2CAN021502

SUBJECT: Anti-Vibration Bar Positioning and Sludge Evaluation Information
Concerning the Spring 2014 Steam Generator Inspections
Arkansas Nuclear One – Unit 2
Docket No. 50-368
License No. NPF-6

**ANTI-VIBRATION BAR POSITIONING AND DEPOSIT LOADING INFORMATION
BASED ON THE SPRING 2014 STEAM GENERATOR INSPECTIONS**

Figure 2

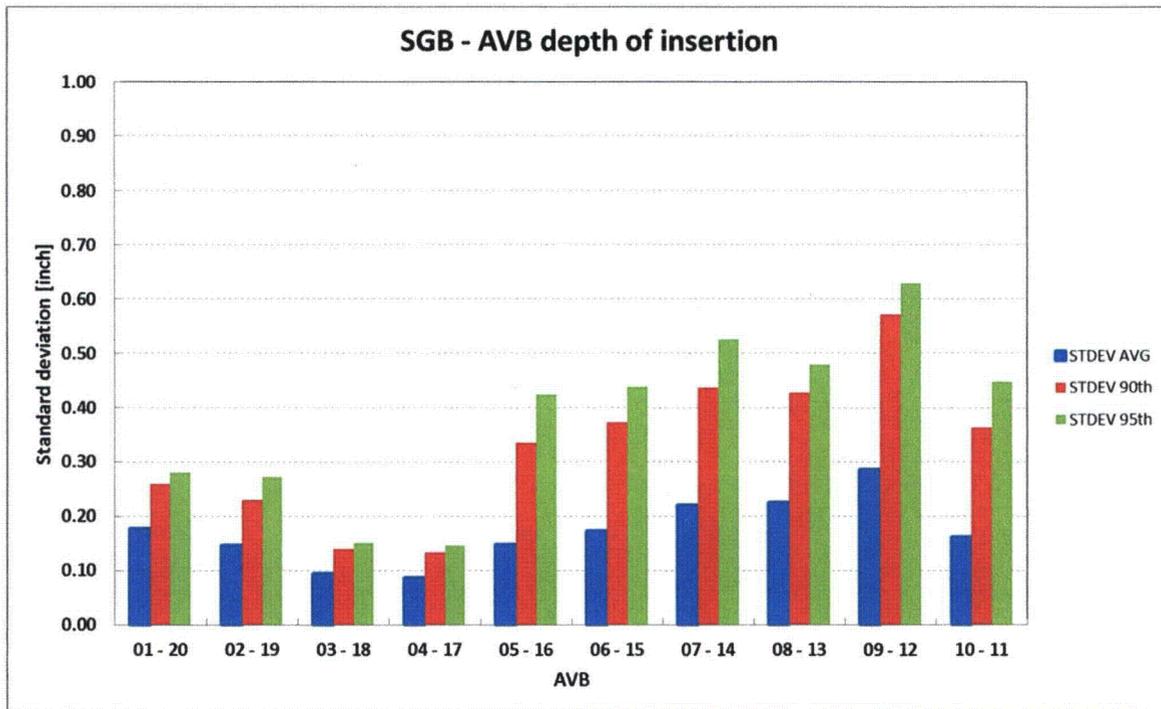
There are AVB assemblies that do not reach typical depth of insertion. The penetration depths are associated with the low row tubes which experience minimal flow velocities. Therefore there is little risk of a vibrational issue. In Figure 2 below, the depth of insertion for the various AVBs

is listed for Steam Generator B (SGB). SGB was bounding for Steam Generator A (SGA). As identified in the figure, the largest 95th percentile value was slightly higher than 0.6 inches of actual versus design depth.

Figure 3

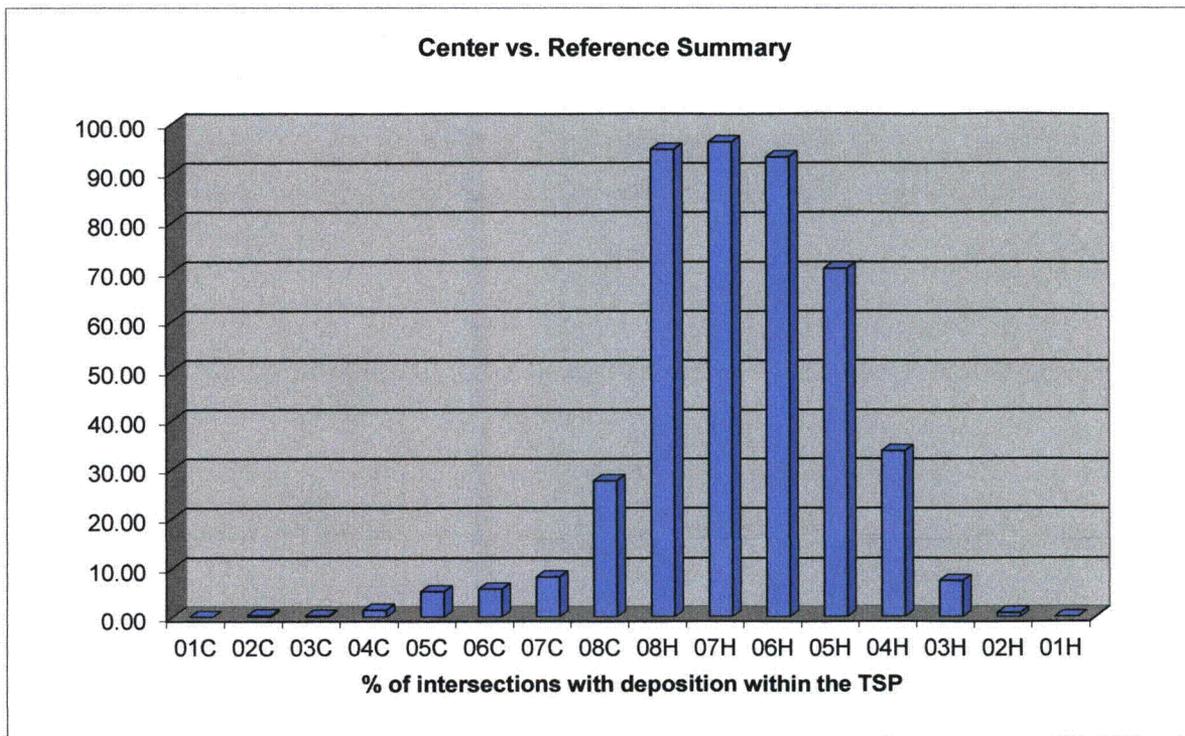
Figure 3 plots the percentage of broached holes per support plate for SGA which have deposition identified by the "CentRef" measurement (i.e. contained within the support). As seen in the figure, greater than 90% of the hot leg side and 25% of the cold leg side of the TSP have deposit identified within the support. The one inch deposit measurements immediately above and immediately below the support resulted in similar distributions.

Figure 4

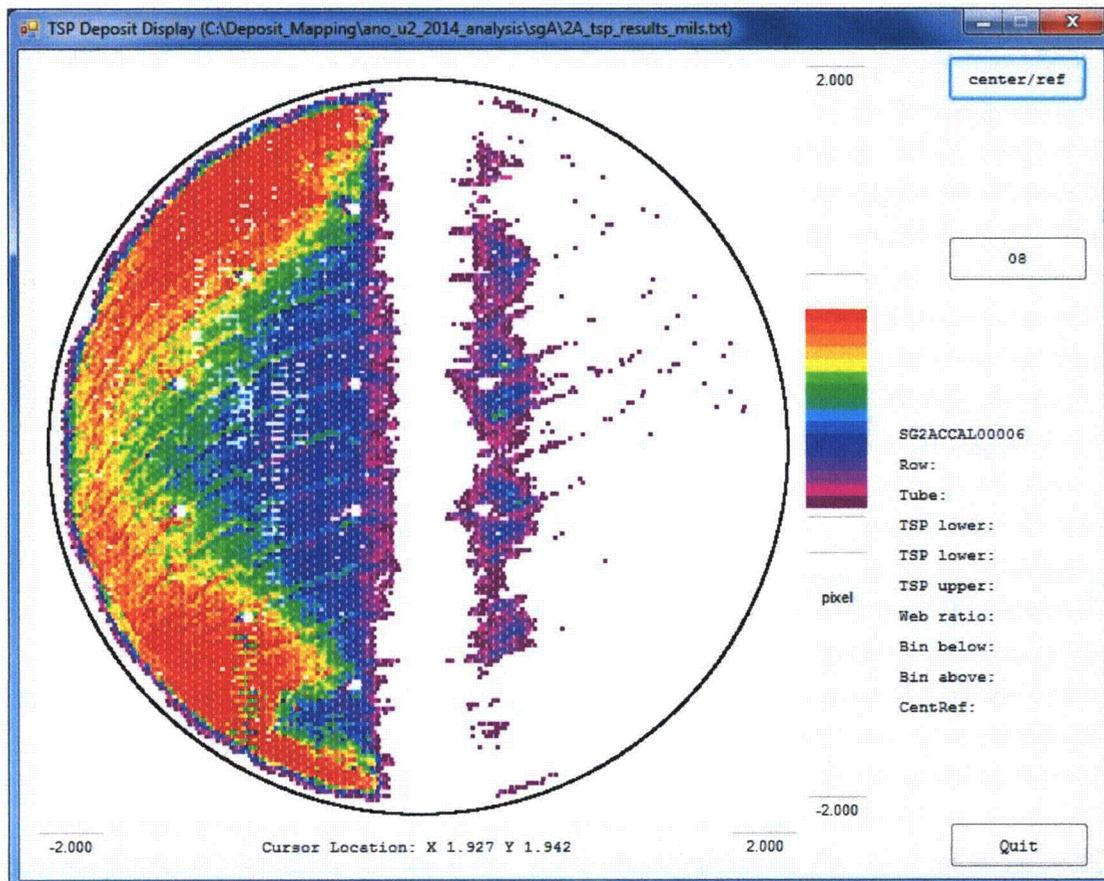
Figure 4 provides a qualitative look at the deposits in SGA. Quantitative values would require development of a specific sludge standard so voltage can be related to sludge depth.
